Delegated Decision - Report of the Head of Development Management and Building Control

3638/APP/2025/2108

Applicant: **Frough Ltd c/o Sphere25**
Site Address: **Former Regal Cinema 233 High Street Uxbridge**
Proposal: **Change of use of existing nightclub (Sui Generis) to a banqueting suite (Sui Generis) and development of a hotel (Use Class C1) including the change of use of existing gymnasium (Use Class E) and associated landscaping, car and cycle spaces (Part retrospective).**
Summary of Recommendation: **REFUSE planning permission**

Image 1 – Congestion on High Street during a banqueting hall event (December 2025)

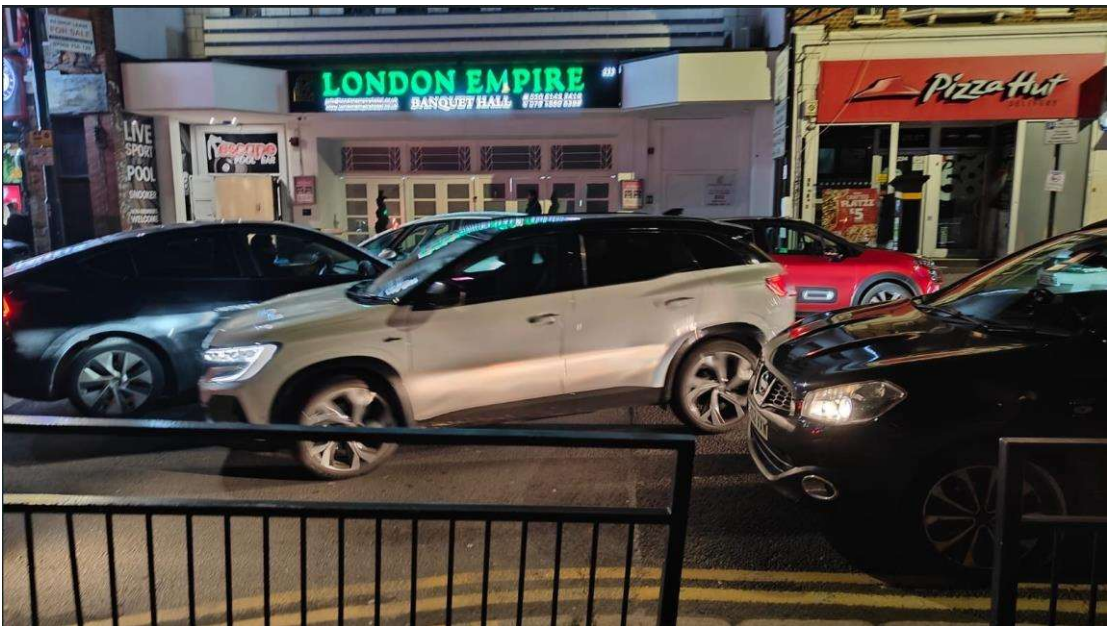
7.56 Due to the constraints of the site, the formal basement parking in the proposed hotel and the area in front of the hotel (which is partly outside of the applicants control) would not be able to readily accommodate the vehicle movements associated with the dropping-off and picking-up of patrons of the banqueting hall, which would be of a significant number in a concentrated period of time. Given the result would demonstrably be injudicious parking and severe traffic congestion on the High Street and the local highway network (see photographic evidence below of recent unauthorised events held at the former Regal Cinema, it is considered that this matter is fundamental to the acceptability or otherwise of the proposed development and thus not a matter that could be resolved through imposition of a planning condition. The applicant was made aware of concerns around pick-up and drop-offs, however no information has been submitted. A condition to secure a pick-up/drop-off scheme would fail the relevant tests, given it would be in response to a fundamental planning issue (as noted above). Further, the LPA is not convinced that a suitable pick-up/drop-off scheme can be achieved given the site constraints and the high number of pick-up/drop-off movements envisaged.

increase the risk of collisions and accidents (refer to Highway Officer detailed comments in Table 2 (above)). No information has been submitted by the applicant to explain or clarify how the banqueting hall would be managed by the operator to avoid such occurrences.
